August 11, 2022

RE: Discharge Permit Renewal and Invoice, DP-1342, City of Gallup WWTP

NMED sent the previous City of Gallup WSD Director, Tim Bodell, a draft permit dated May 4, 2022, and also made the draft available to the public for a 30-day comment period. NMED received comments from the City of Gallup and provides the following responses:

FIGURE 2
GALLUP WWTF
MONITOR WELL No. 5

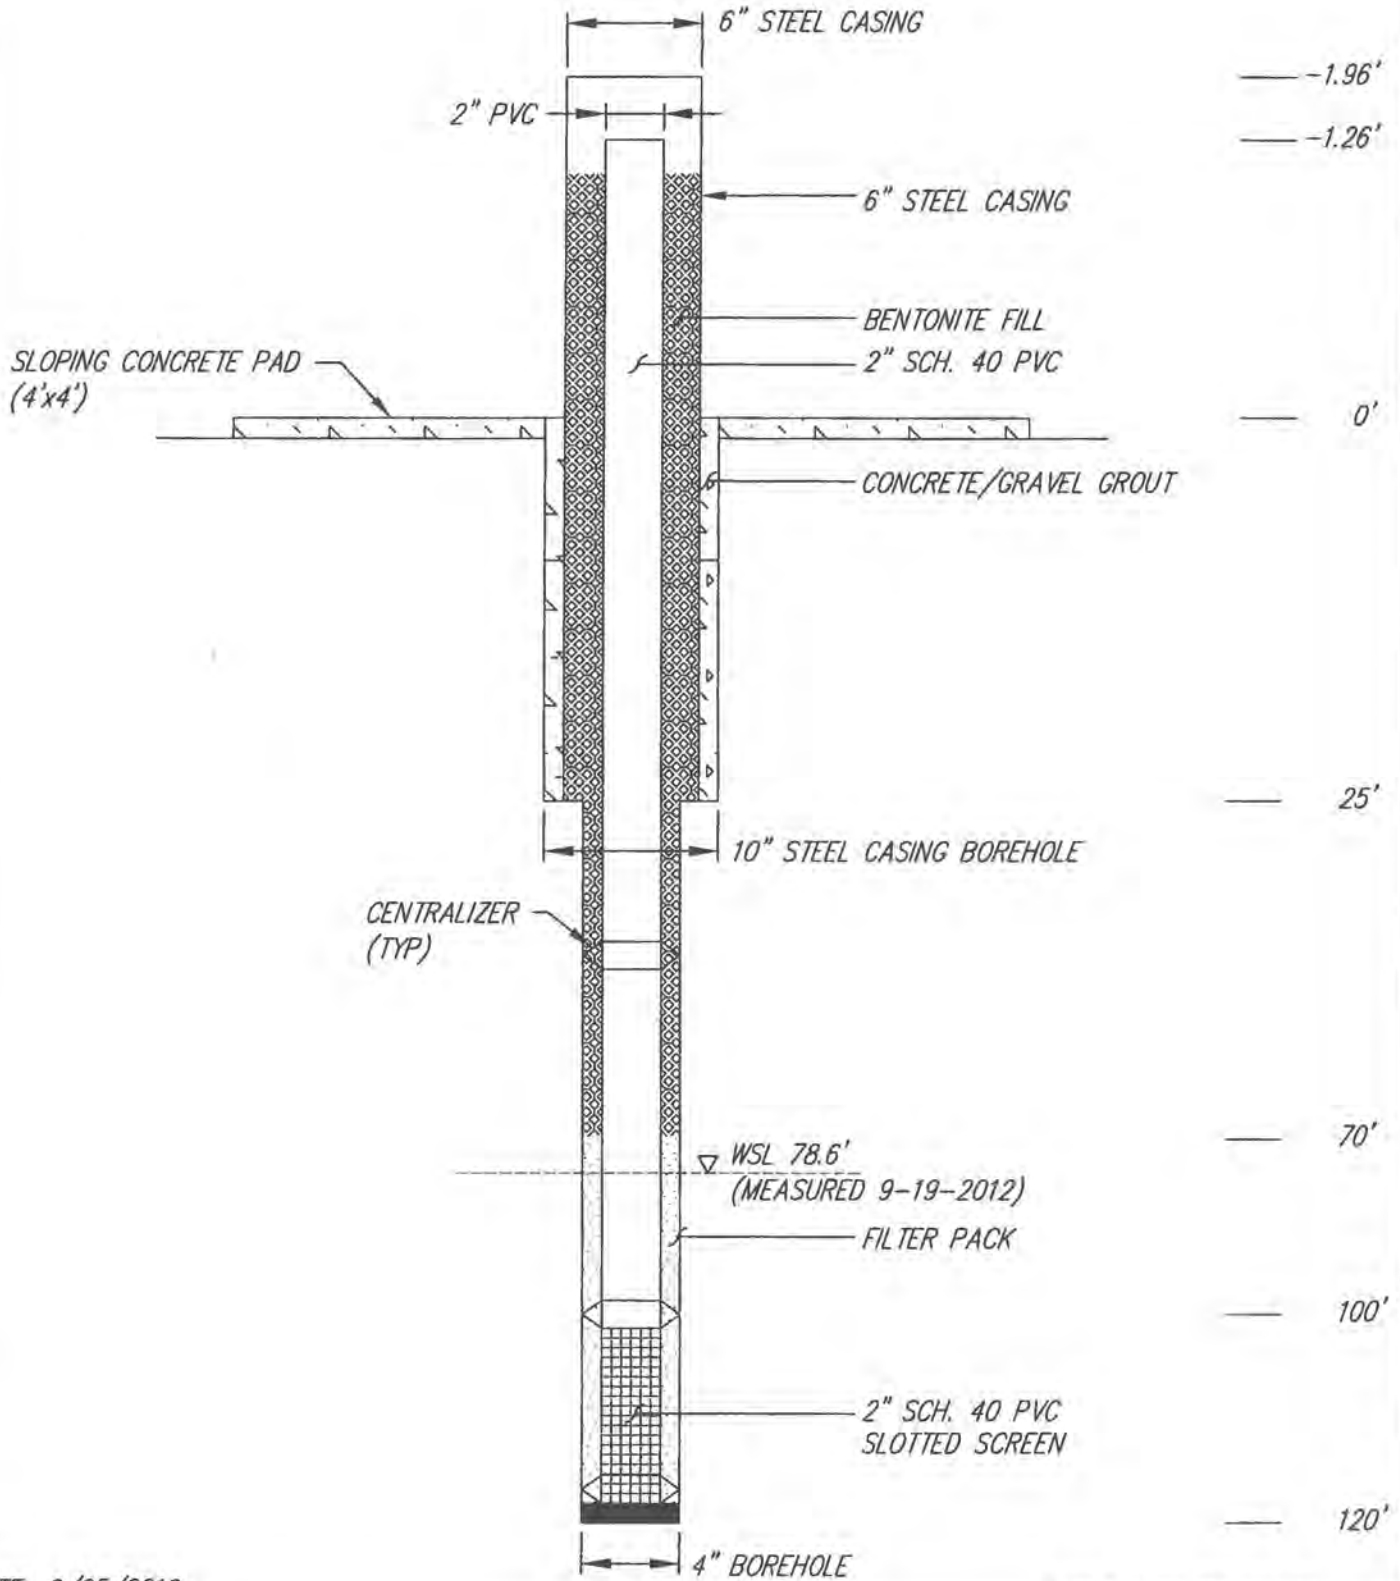
Monitoring Wells No. 5 and No. 6 were constructed and completed under NMED Ground Water Bureau direction in 2012. These wells replaced Monitoring Wells No. 2 and 3 as directed in DP-1342 and DP- 418 dated 2011. The wells deviated from NMED's typical casing/screen schedule to match the perforation interval of the existing monitoring well nos. 2 and 3. The casing, well screen/perforation and filter pack were approved by NMED Ground Water Bureau. Monitoring Well Nos. 5 and 6 deviations from typical NMED Monitoring Well Construction was approved by NMED therefore there is no need to replace MW No.5 and MW No. 6. There is also no need to abandon existing MW No. 5 and No. 6.

12. MWs 5 and 6 were drilled to approximately 120’ bgl with perforated intervals from 100’ to 120’. The wells were drilled to this depth to ensure there would be water to sample within each well. See Exhibit MD-2 - City of Gallup Wastewater Treatment Plant Monitoring Well Installation Report for the 2012 Well Log Data, Exhibit MD-3 for Monitoring Well State Plane Coordinates and elevations and Exhibit MD-4 for groundwater depth and flow direction.

Response: As discussed at our 6/6/2022 meeting regarding monitoring well concerns, the goal of NMED's Monitoring Well guidance is to ensure Permittees and NMED can assess the condition of groundwater from the top of the aquifer. Although NMED's 5/9/2012 correspondence to the City of Gallup note that MW-2, MW-3, and MW-4 well logs may indicate geology that might result in confined aquifer conditions, there is no firm confirmation of a confining layer in any of the 2012 correspondence on file. There is no record of the City of Gallup requesting a modification from the Monitoring Well Guidance with respect to screen placement. Specially, the City of Gallup's 6/5/2012 letter to NMED states "...At such time

groundwater is encountered, screened intervals will be installed no more than five (5) feet above and 15 feet below the water table." Per the 9/27/2012 DePauli Engineering and Surveying, LLC, monitoring well installation report, water moisture was detected at 80 and 90 feet while drilling MW-5 and MW-6, respectively. Therefore, the screen interval should have been placed at 75 to 95 and 85 to 105 feet, respectively, vs. at 100 to 120 feet for both wells. Regarding the need to plug and abandon existing monitoring wells that are no longer in use, they must be properly plugged and abandoned to avoid potential future ground water contamination pathways.
